PRODUCT UPDATE

CHANGE TO EXISTING PRODUCT NEW PRODUCT INFORMATION DATE: February 19, 2019

IP10 and IPU10 0.5t Vertical Clamps

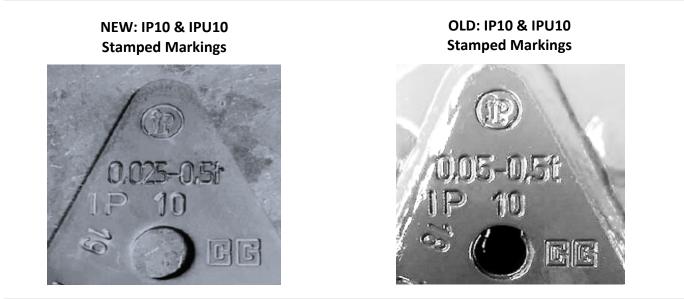
CrosbyIP 0.5t IP10 (p/n 2701674) and IPU10 (p/n 2701675) Vertical Clamps have been updated to allow for a minimum WLL of 5% of maximum working load limit. All other IP sizes and models will remain at 10% of maximum working load limit.

An authorized CrosbyIP repair center may re-stamp the minimum working load limit on clamps previously purchased; provided that the year of manufacture is no older than 2015 <u>and</u> the authorized repair center ensures the IP clamp meets all inspection criteria required by Crosby.

To determine the year of manufacture, locate the two digits prior to the serial number. See image below for clarity.
